**Department of Energy**  
Carlsbad Field Office  
P. O. Box 3090  
Carlsbad, New Mexico 88221  
SEP 29 2004

**Subject: Response to EPA May 20, 2004 Letter on CRA**

In response to the Environmental Protection Agency's (EPA's) letter of May 20, 2004, and the request for information received during the EPA Run Control Inspection the Week of August 9, 2004, the U.S. Department of Energy (DOE) is providing information to answer the questions included in the enclosure to that letter and answer the inspection information request.

Figure 1. Comparison of SANTOS and SPECTROM-32 Results for Three Different Gas Generation Rates.

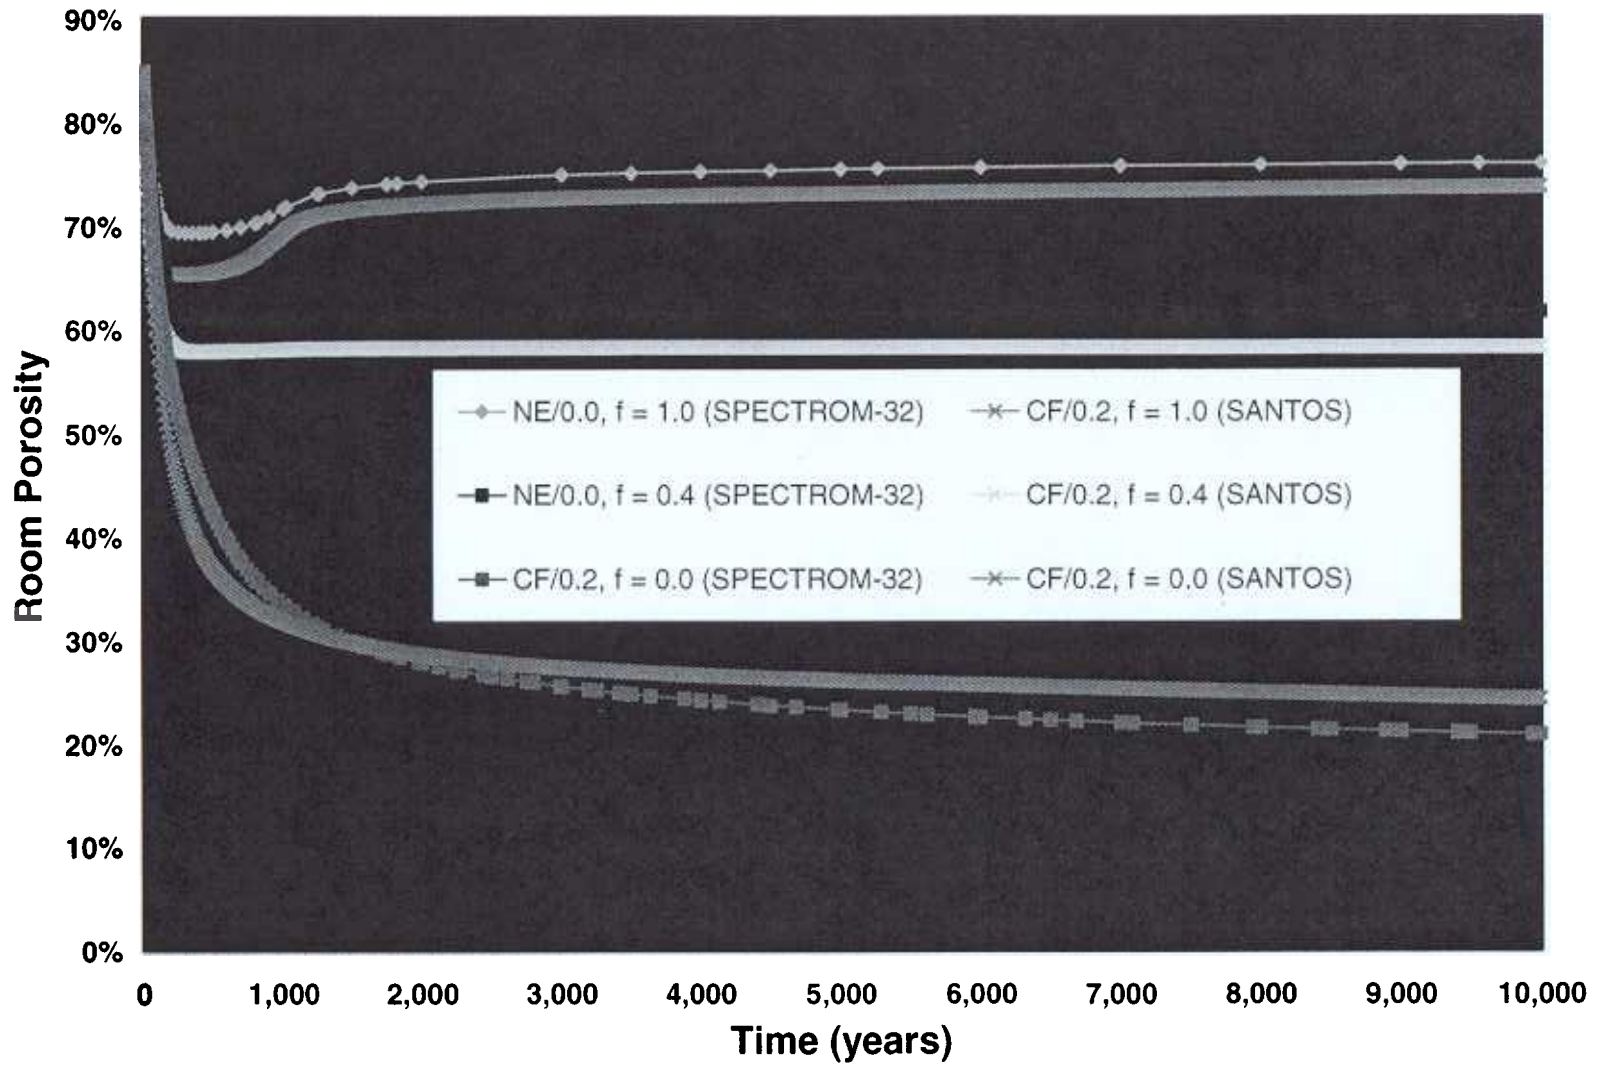
In item G-8-2 of Cotsworth (2004), the EPA proposed the following: *PA Computer codes - SANTOS, NUMBERS and DRSPALL*

- 1. DRSPALL, 1.0 is regression tested on the Compaq ES45 and 8400;*
- 2. NUMBERS meets the QAP 19-1 requirements; and*
- 3. SANTOS is properly evaluated for accuracy."*

Figure 1 compares the average room porosity results obtained from SPECTROM-32 and SANTOS for three different problems. Figure 1 uses the following abbreviations:

Figure 1 compares room porosity results obtained with SPECTROM-32 and SANTOS for gas generation rates ( $f$ ) of 0, 0.4, and 1. For the case with no gas generation, the SPECTROM-32 porosity results are slightly higher than the SANTOS results earlier in time and slightly lower than the SANTOS results later in time. At 10,000 years, the SPECTROM-32 and SANTOS results differ by about 3.4% room porosity (i.e., 20.9% versus 24.3%). For the gas generation cases ( $f = 0.4$  and  $f = 1.0$ ), the SPECTROM-32 results were computed using a nonlinear elastic model for the TRU waste with a Poisson's ratio of zero; whereas, the SANTOS results were generated using the crushable foam model for the TRU waste with a Poisson's ratio of 0.2. Despite these TRU waste model differences, the SPECTROM-32 and SANTOS room porosity results are quite similar with the SPECTROM-32 results being consistently higher than the SANTOS results. At 10,000 years, the SPECTROM-32 ( $f = 0.4$  case) result is about 3.4% room porosity higher than the SANTOS result (i.e., 61.7% versus 58.3%). At 10,000 years, the SPECTROM-32 ( $f = 1.0$  case) result is about 2.2% room porosity higher than the SANTOS result (i.e., 76.0% versus 73.8%).

**Figure 1. Spallings Releases Calculated Using the Average Radioactivity Over All CH-TRU Waste Streams**

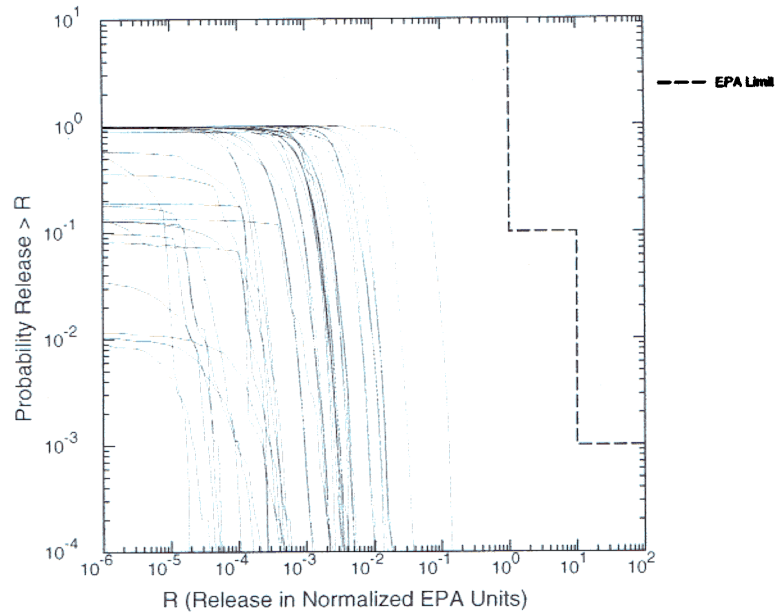
**EPA Comment****C-23-10 Ch 6, pg 6-166, lines 23 to 24**

*The CRA states that “spallings are assumed to be derived from a sufficiently large volume of waste that container-scale variability can be neglected.” While we accepted this assumption in the original certification decision, since then DOE has used a number of different container configurations-such as ten drum overpacks and supercompacted waste-with greater frequency than estimated earlier. In addition, the new DRSPALL code generally predicts much lower release volumes. For these reasons, neglecting container-scale variability may not be a valid assumption.*

*DOE must fully justify the existing waste spall model given the changes in waste container since the CCA and the new spallings model results or must rerun the CRA PA with assumptions that better reflect the container variation.*

Figure 1 shows the 100 complementary cumulative distribution functions (CCDFs) for CRA Replicate 1 spallings releases that were computed using the average radioactivity across all CH waste streams. Fifty-eight of the 100 vectors fall off-scale with values too low to plot. Figure 2 shows the 100 CCDFs for CRA Replicate 1 spallings releases that were computed using the randomly sampled waste streams. Fifty-seven of the 100 vectors fall off-scale.
